Discharge of planning conditions design note

Project name **Plot 10A First Street Manchester**
Project no. **1620007819**
Client **First Street Developments Ltd.**
Prepared by **Conor O'Loughlin**

1.1 The following technical note has been prepared in response to comments received from the LLFA on the 3rd October 2023.

Website: www.cundall.com
Drawing No.
FSP10A-CDL-XX-13-DR-P-11131

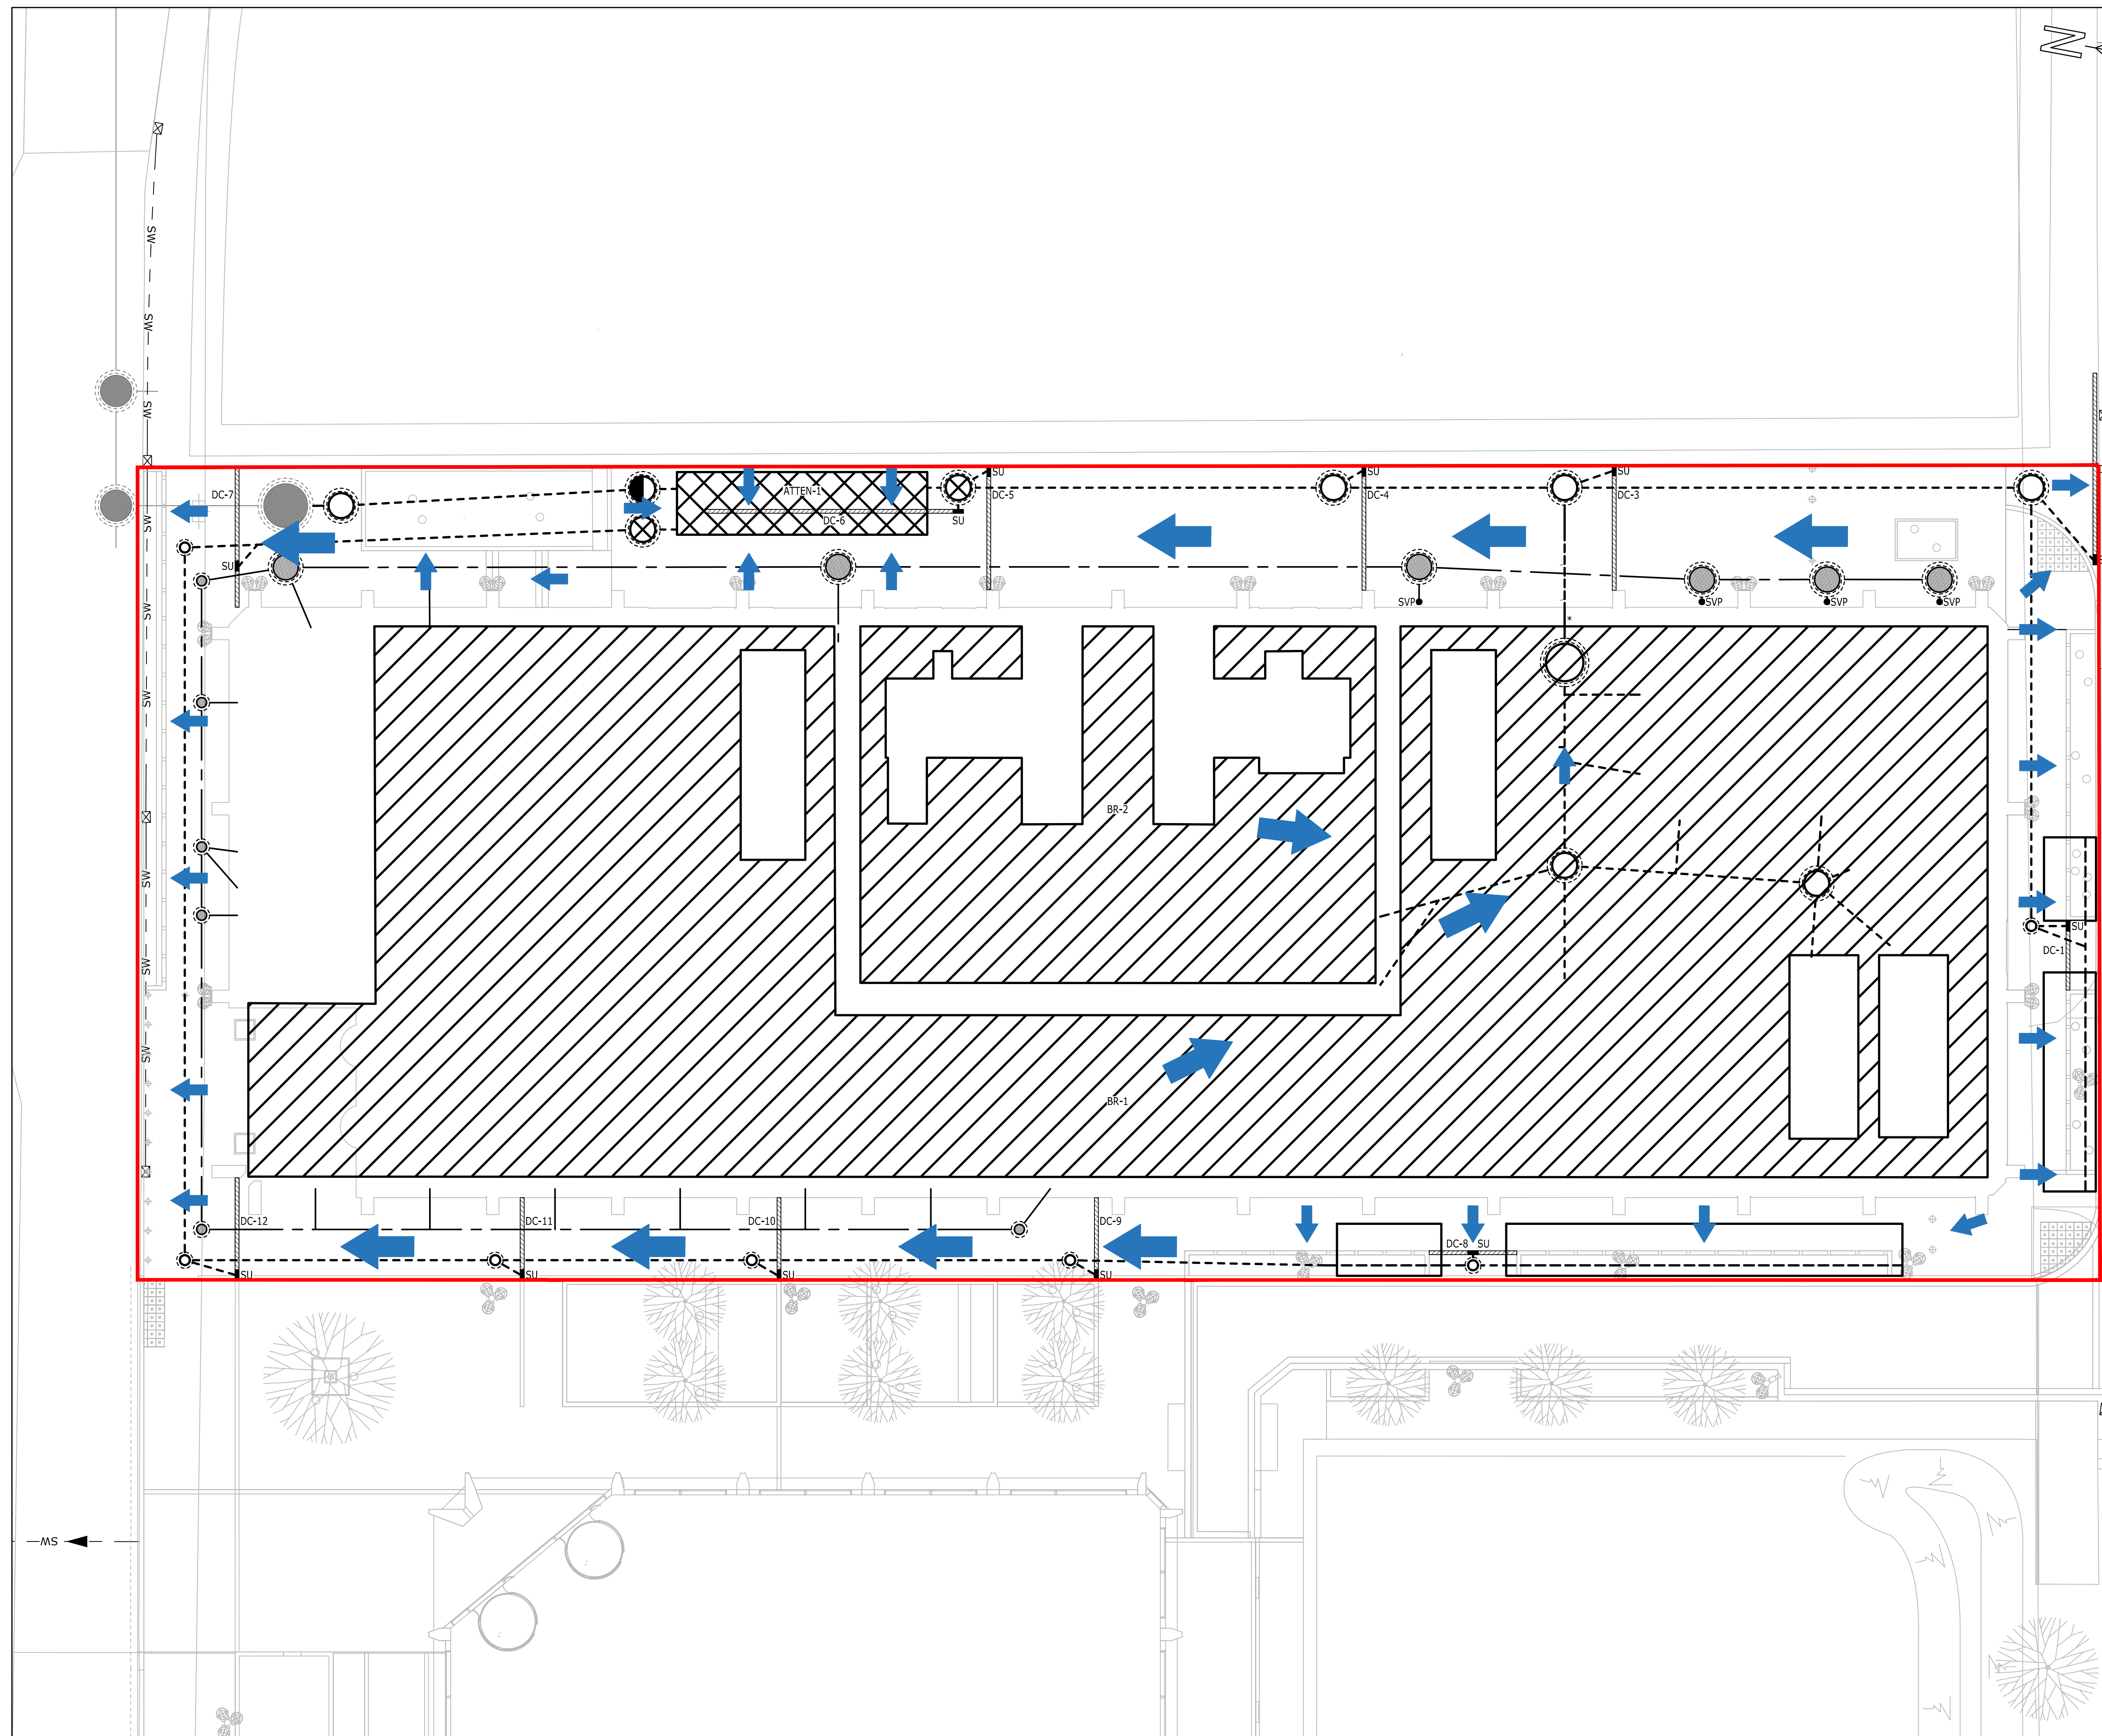
LLFA Comments	Ramboll Response
Please provide evidence of appropriate easement applied to attenuation tank, to be specified & confirmed by the project engineer.	No easement has been set for the attenuation tank as tank to remain private. However, attenuation tank has been sized & positioned on plan through coordination with the landscape architect & external MEP engineer to suit site loadings.
Please provide the following drawings referenced on p.36 of drainage strategy - FSP10-CDL-ZZ-XX-SC-P-15003 and FSP10-CDL-XX-B1-DR-P-10991	Drawings provided within Appendix A.
Please provide drawings showing connectivity of blue roofs with wider network (including the following drawings referenced on p.37 of drainage strategy: FSP10-CDL-XX-12-DR-P-11121 and FSP10-CDL-XX-13-DR-P-11131)	Drawings provided within Appendix B. Connectivity to wider network is provided through the above ground drainage network. Refer to schedule drawing (FSP10A-CDL-ZZ-XX-SC-P-15003) as provided within Appendix A for connectivity into below ground drainage system.
